Subject: January 2012 Inspection Report

Cameco Resources, Permits 603 & 633

# PERMITS 603 & 633 INSPECTION REPORT JANUARY 2011 DISTRICT 1/LAND QUALITY DIVISION

Figure 1 South slope of drainage in MU-9; straw waddles used to control sedimentation; steep slope without vegetation likely to continue to erode

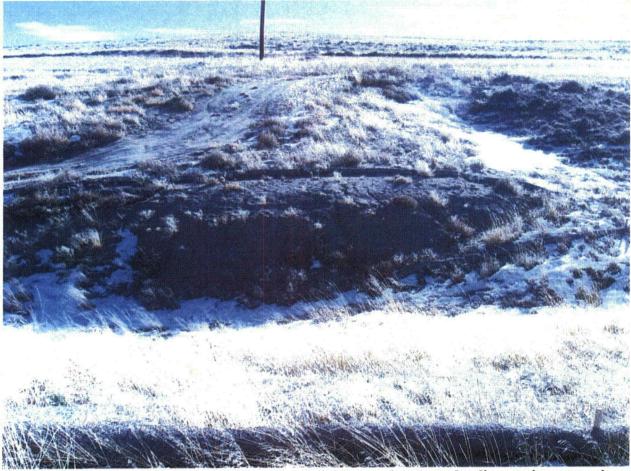
• slopes of drainage are stable with waddles functioning; few sandy exposed areas on south slope could use additional revegetation (Figure 1)

- The drainage slopes in MU-9 appear stable and straw waddles have been utilized to protect revegetation. There are barren areas particularly along the south slopes that will likely erode further if additional prevention is not provided such as slope reduction and vegetation. LQD will continue to monitor the drainage for control of sediment into the flow path of the drainage.

Figure 2 MU-10 wellfield development; topsoil stockpiles placed away from drilling activities and clearly marked, routes for vehicle use are clear, areas without disturbance can be identified, sediment control placed around stockpiles

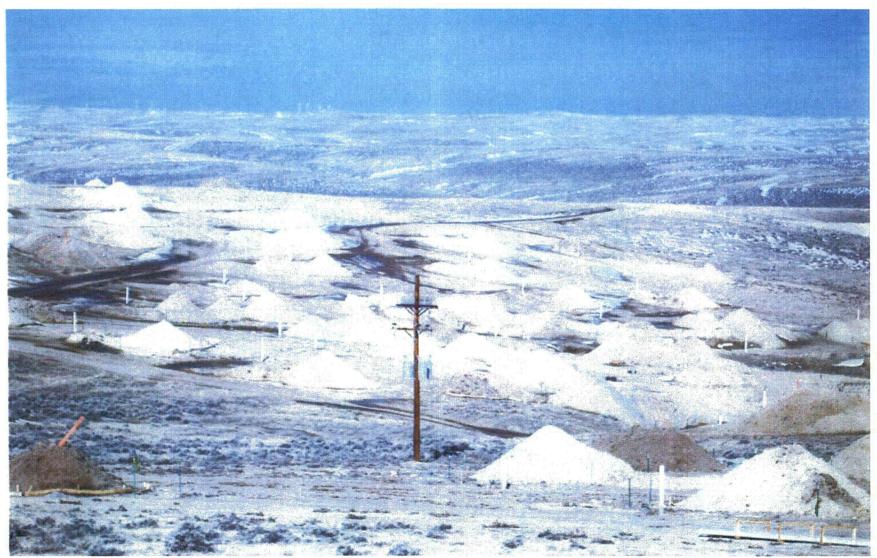
- waiting on pump test approval from LQD;
- wellfield development in progress; topsoil salvage and protection was exceptional with straw waddles at the base of the piles and piles placed away from the activity at the well; drill traffic appeared to be staying on designated pathways with notable undisturbed areas to enhance the revegetation during wellfield reclamation (Figure 2 & 3)

- CR is doing a much better job with managing surface disturbance during wellfield development with regard to topsoil salvage and protection and restricting disturbance to pathways to drill sites. The decision by the former LQD Administrator to not require topsoil stripping in wellfield disturbance areas was based on minimizing the disturbance and providing necessary protection from sediment where it is needed. CR is now making this effort as was identified in MU-10. This effort is greatly appreciated.
